UNITED STATES PATENT AND TRADEMARK OFFICE

APPLICATION NO.	FILING DATE	FIRST NAMED INVENTOR	ATTORNEY DOCKET NO.	CONFIRMATION NO.
10/675,668	09/30/2003	Juan J. Becerra	107059-0012P1	5796

Office Action Summary	Application No.	Applicant(s)	
	10/675,668	BECERRA ET AL.	
	Examiner	Art Unit	
	Raymond Alejandro	1745

DETAILED ACTION

Figure 2 clearly illustrates the fuel container design:

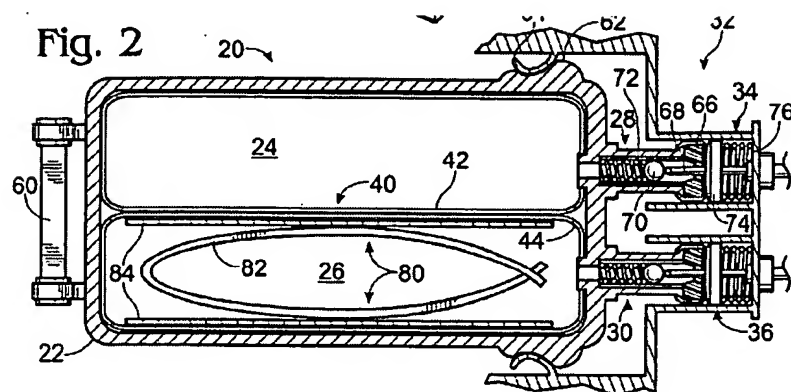
Prasad et al disclose a fuel cell system including a direct methanol fuel cell (P0025, 0045); the fuel cell includes electrode and an electrolyte disposed therebetween (P0002); a fuel supply including fuel storage area 24 configured to hold a fuel solution, a fuel solution outlet 28 configured to pass the fuel solution from the fuel storage area 24; a waste storage area 26, a waste inlet 30 configured to pass waste into the waste storage area 26 and a movable barrier 40 separating the fuel storage area 24 and the waste storage area 26 and configured to move as fuel solution is passed from the area 24 and waste solution is passed into area 26 to simultaneously decrease the volume of area 24 and increase the volume of area 26 (ABSTRACT).

Prasad et al disclose that waste storage area 26 receives waste from the fuel cell (ABSTRACT/P0036). *Thus, it can be asserted that waste storage area 26 receives fuel cell exhaust from both the anode and the cathode.*

Prasad et al disclose the presence of a pressurizer or any suitable mechanism to pressurize fuel storage area; the pressurizer can be in the form of a spring (P0039).

The fuel delivery system of Prasad et al can also include a pump (P0056) and/or valve means associated with respective outlet/inlets (P0036). *These features permit to control the fuel/effluent flow. The limitation "valve means associated with..." has not been construed as invoking 112, 6th paragraph because it does not comply with at least one of three prongs requirement.*
